Docket No. 70-36
License No. SNM-33

Subject: Response to NRC Questions on the Hematite License Renewal Application

**COMBUSTION ENGINEERING, INC.
HEMATITE NUCLEAR FUEL MANUFACTURING FACILITY
RESPONSE TO NRC QUESTIONS ON THE
LICENSE RENEWAL APPLICATION
INDIVIDUAL RESPONSES**

**Request for Additional Information
Application Dated November 22, 1989
Combustion Engineering, Inc.
Docket No. 70-36**

FIGURE 10-3 CHEMICAL AND OTHER HAZARDOUS MATERIAL STORAGE LOCATIONS

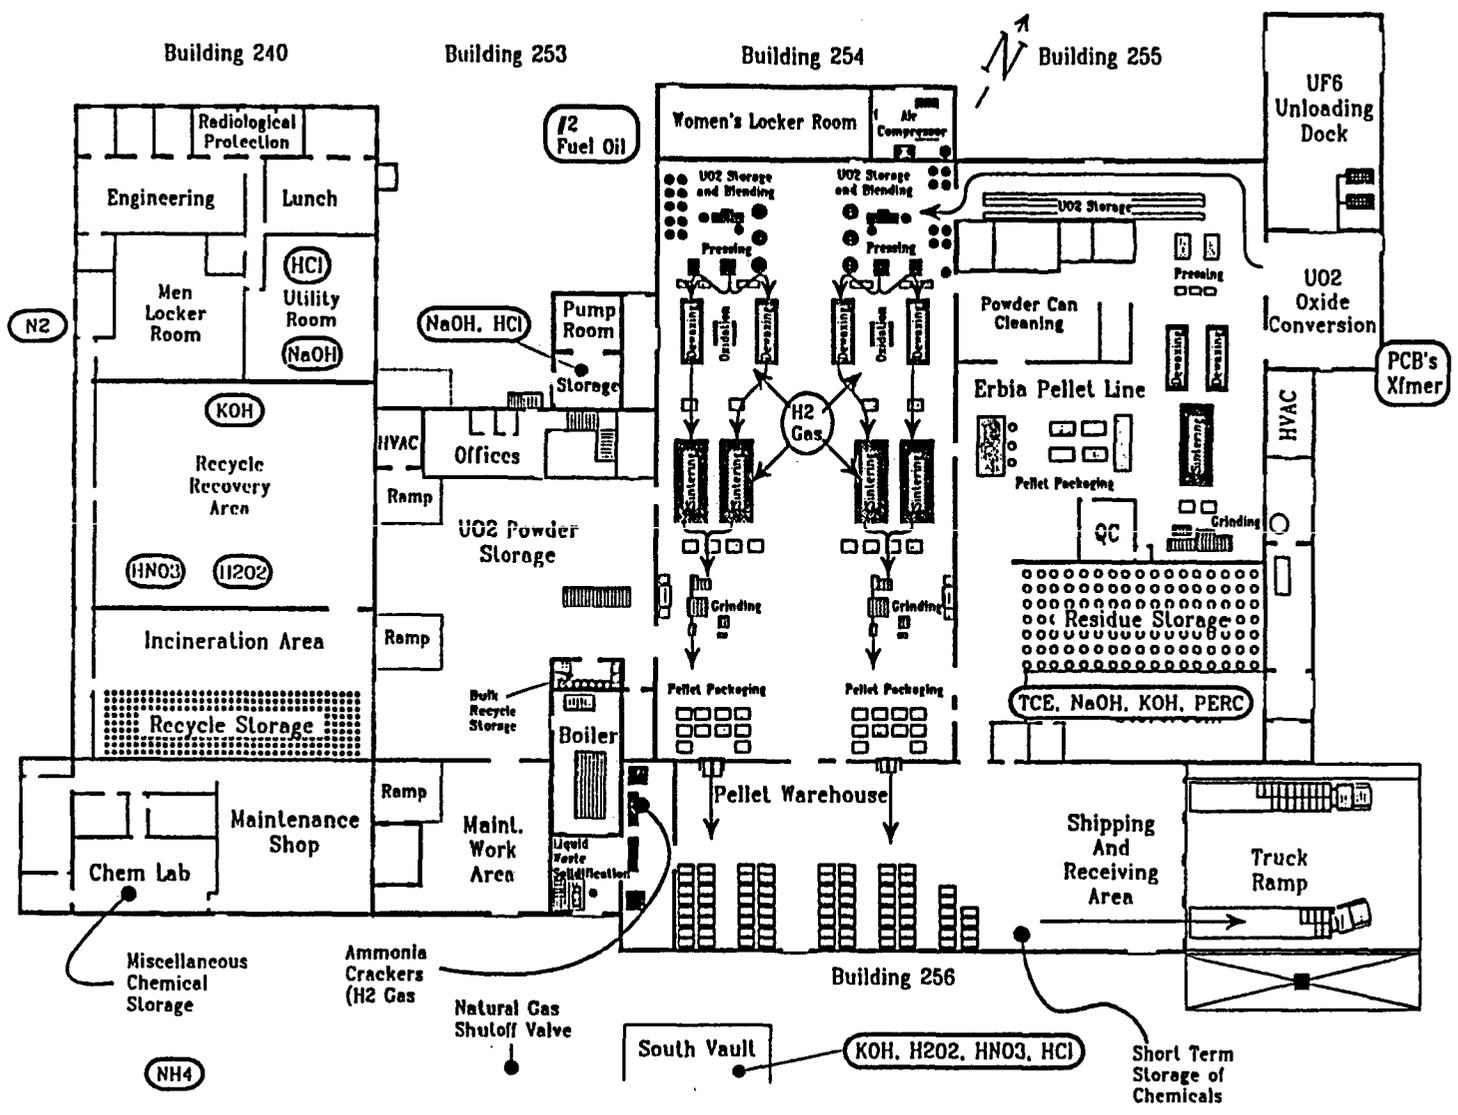
- 10-3 In Section 10.2.6, provide a map indicating the locations of the chemical materials which are stored onsite. For each chemical material, indicate the maximum capacity of the onsite storage.

Section 10.2.6 has been revised to indicate the quantity of each significant chemical stored on the Hematite site. Figure 10-3, "Chemical and Other Hazardous Materials Storage Locations" has been added. Subsequent figures were re-numbered to reflect this addition.
